ATTACHED TO ADMINISTRATIVE APPROVAL
 DATED: October 6, 1999
 BY: MARTIN R. CRAMTON, JR.

TECHNICAL DATA SHEET
 PETITION NO. 98-97 FOR PUBLIC HEARING

DATE: JULY 24, 1998
 PROJECT No. 18084

SUBJECT: Administrative Approval for Petition No. 98-97 by Childress Klein Properties, Inc. Tax parcels 123-041-14, 123-041-15-21 and 123-041-23.

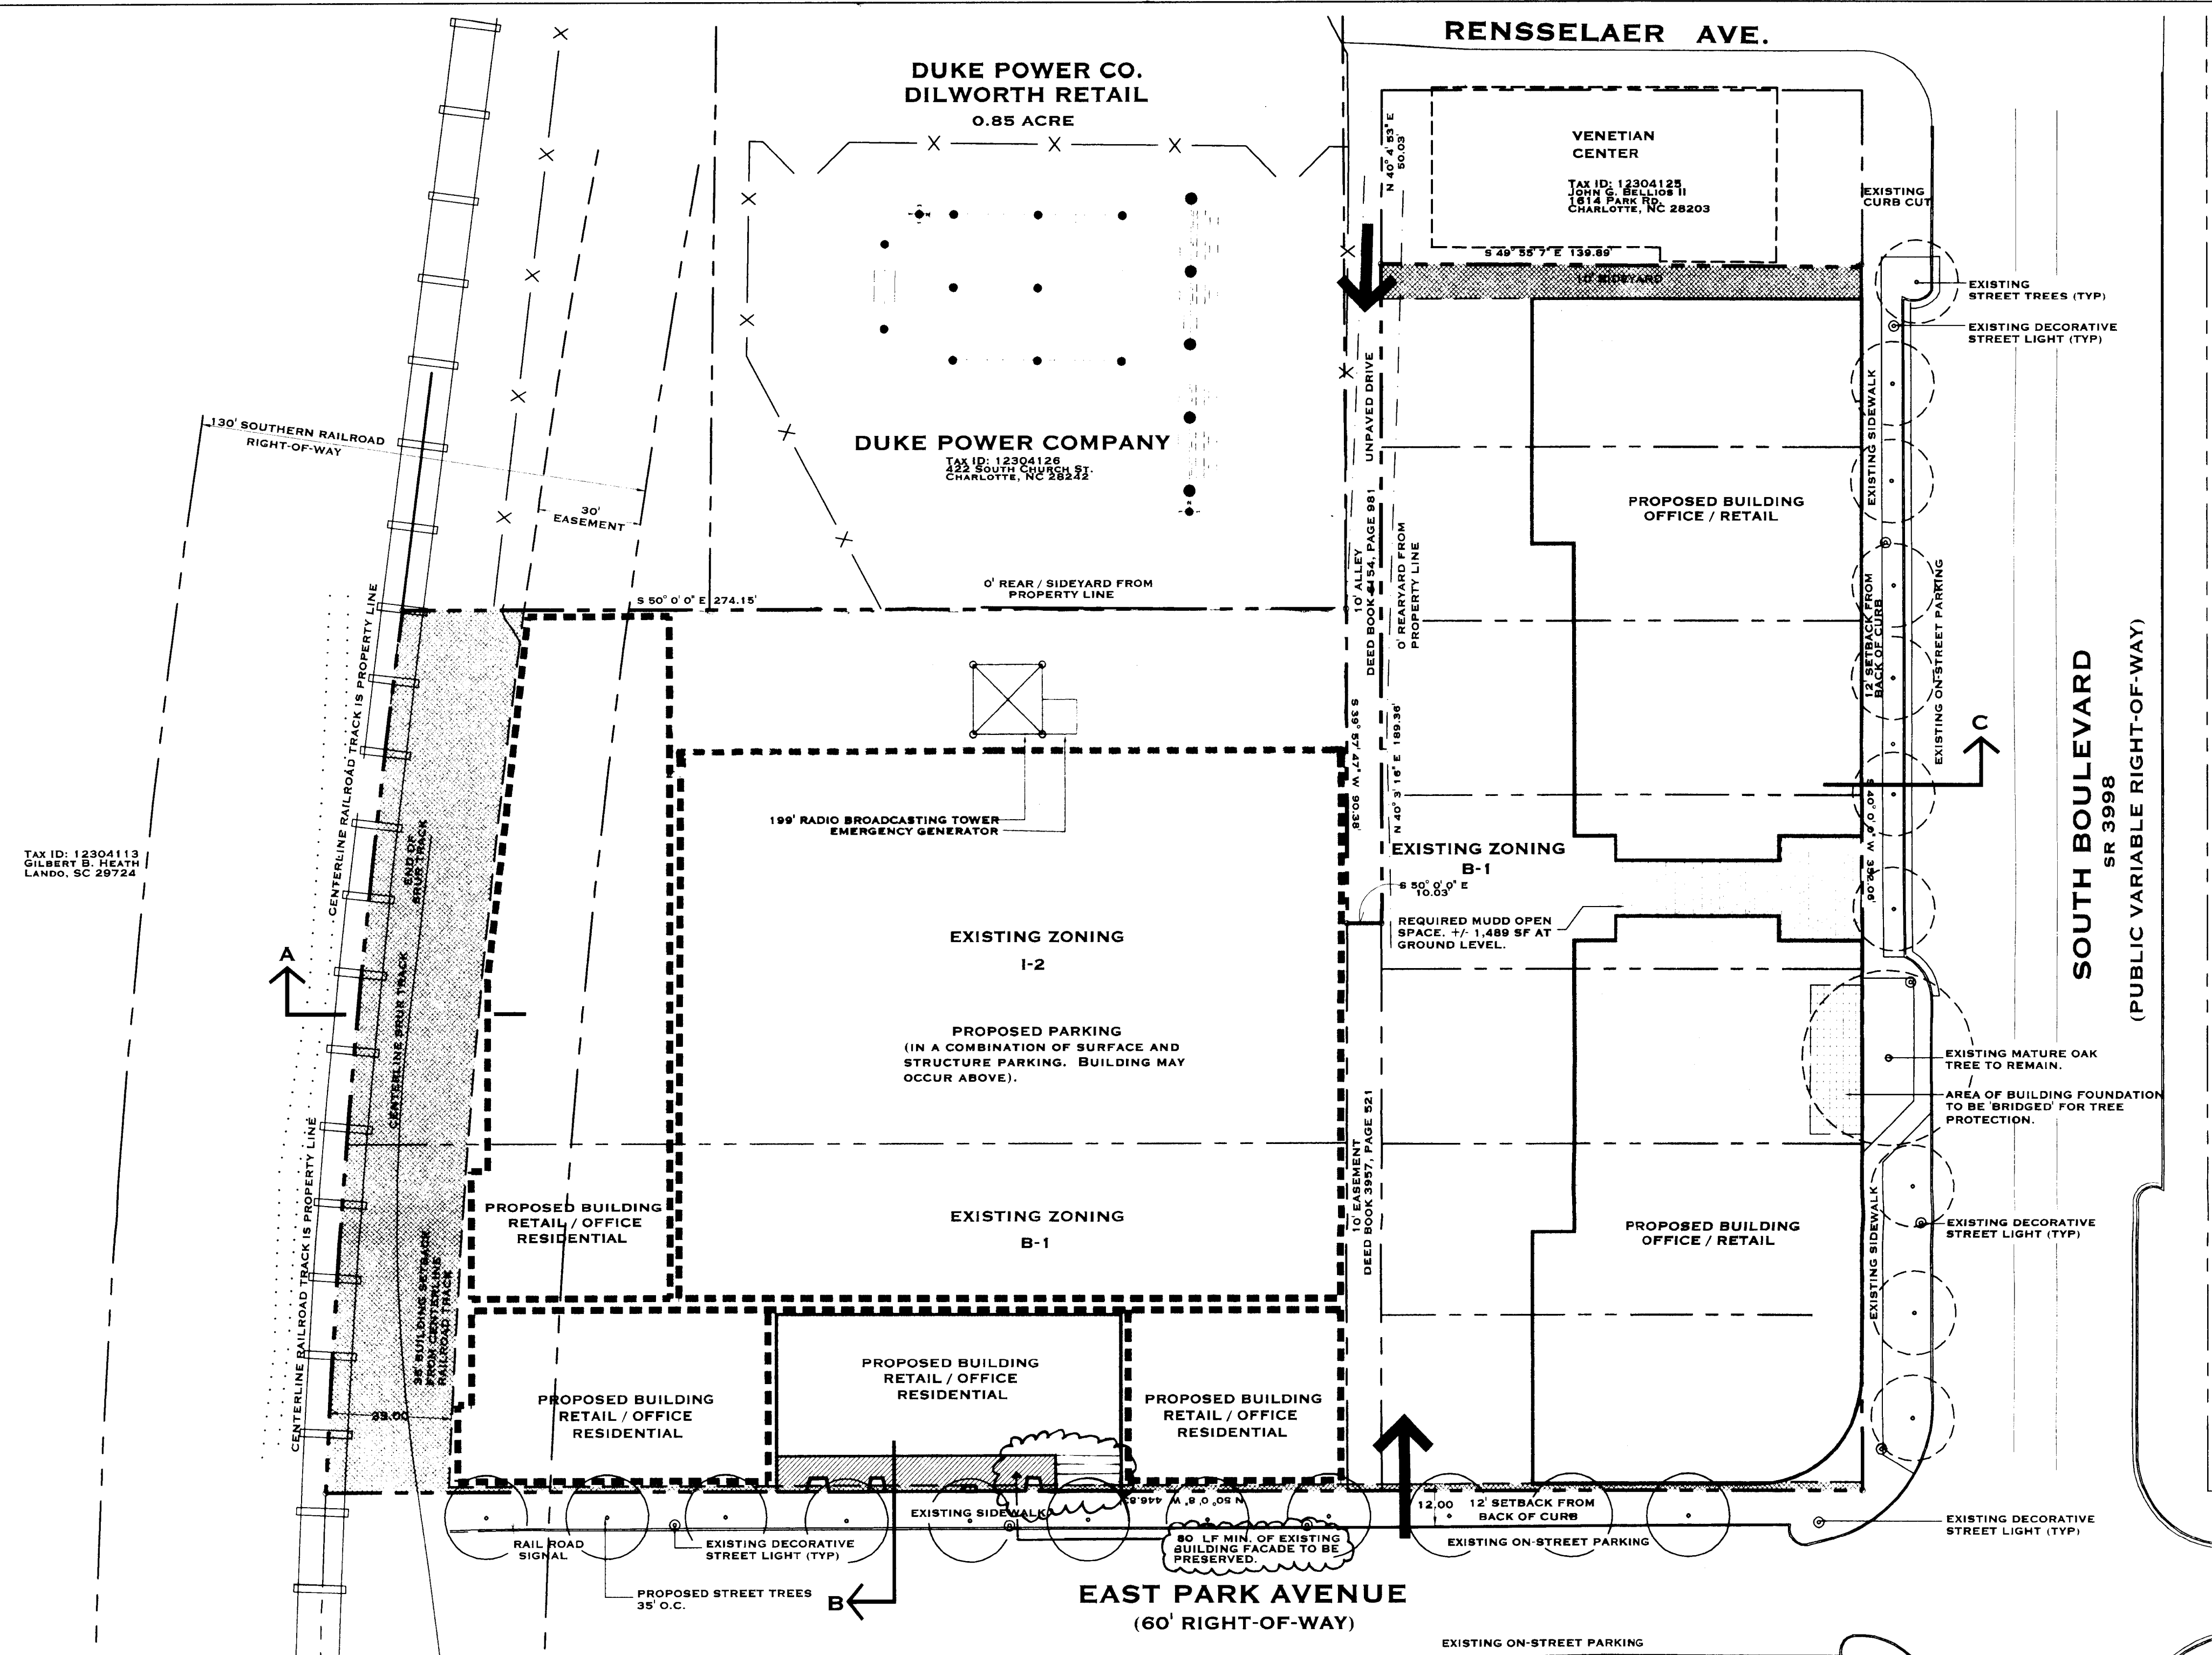
Attached is a copy of the revised plan for the above rezoning petition. The plan has been revised to reduce the amount of building facade that will be preserved along East Park Avenue from 100 feet, to 80 feet. Since this change is minor and does not alter the intent of the development, I am administratively approving this revised plan. Please use this revised plan when evaluating request for building permits and certificates of occupancy.

Existing Structures
 The existing structures on the site shall be razed, except for the preservation of 80 LF minimum of building facade along East Park Avenue as shown on the plan.
